V-4  
(2012)

**APPLICANT:** Susan Matsumoto **PETITION NO.:** V-4  
**PHONE:** 770-645-6031 **DATE OF HEARING:** 01-11-12  
**REPRESENTATIVE:** Spencer Doss **PRESENT ZONING:** R-15  
**PHONE:** 770-318-8062  
**TITLEHOLDER:** Larry C. Matsumoto **LAND LOT(S):** 29  
**PROPERTY LOCATION:** On the south side **DISTRICT:** 1  
Vendome Place, west of Monceau Way **SIZE OF TRACT:** 0.385 acre  
(4560 Vendome Place). **COMMISSION DISTRICT:** 3  
**TYPE OF VARIANCE:** Waive the impervious surface from the maximum allowable of 35% to 36.94%.

**COMMENTS**

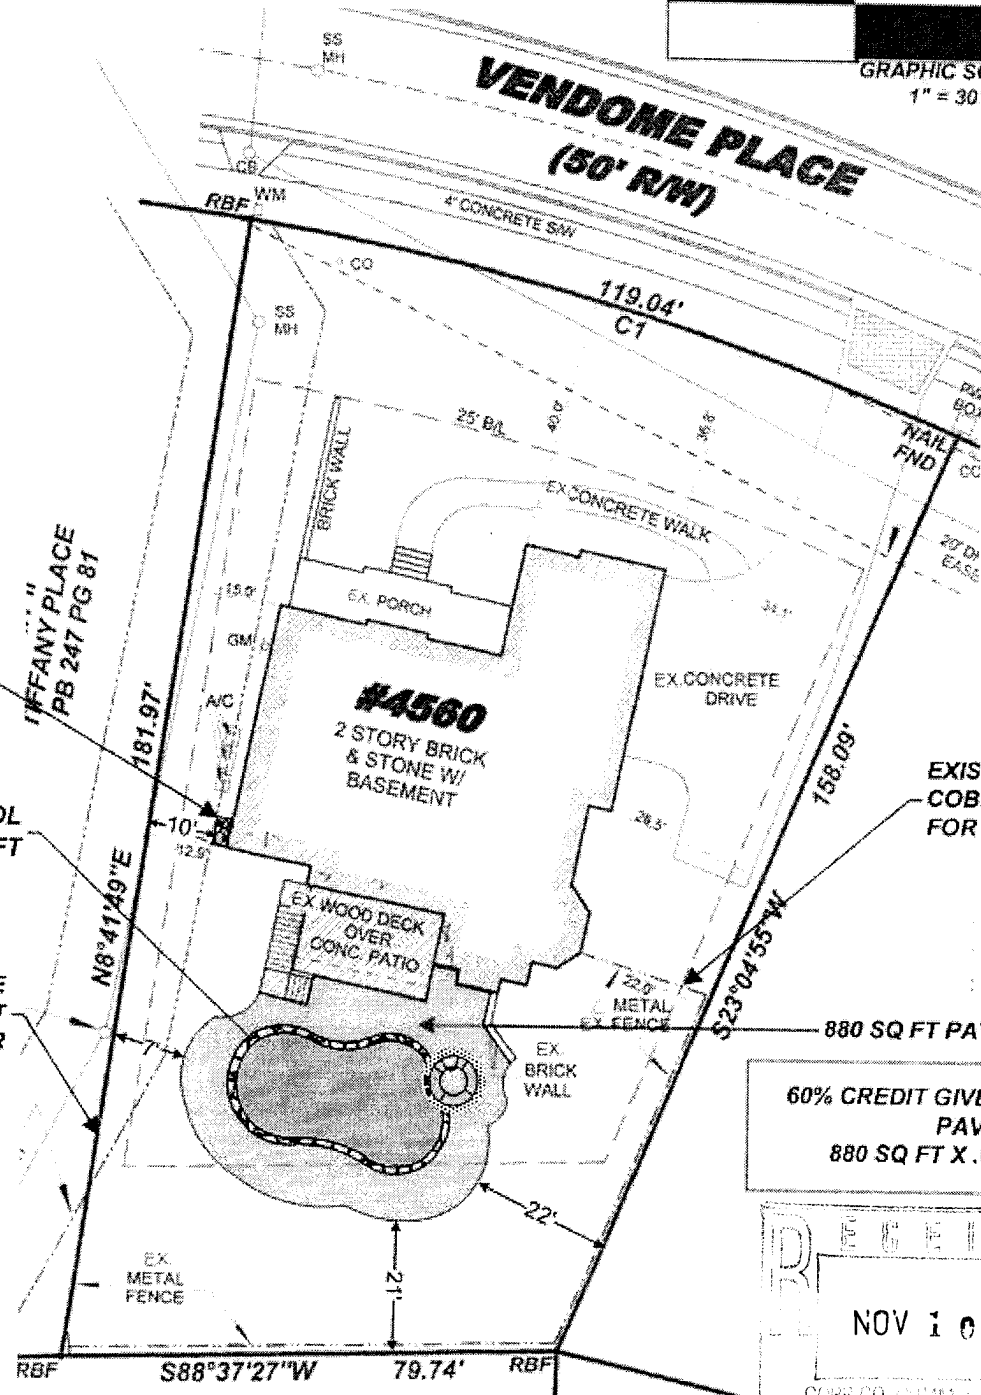
**SITE PLAN REVIEW:** Any improvements associated with the pool installation must be located at least 2 feet away from the edge of the sanitary sewer easement.

**STORMWATER MANAGEMENT:** This pool is already installed. The pool contractor must verify that the pavers used for the pool deck meet the County's requirement for pervious pavers and were installed per the manufacturer's specifications. It is possible for this parcel to meet the 35% coverage limit without a variance by removing the driveway extension and replacing the front walkway with stepping stones.

**SEWER:** The "proposed EQ", as shown on drawing, violates the 2 foot sanitary sewer easement side setback requirement per County Code 122-123. Brick Paver Pool Deck must be at least 2 feet from edge of sanitary sewer easement.
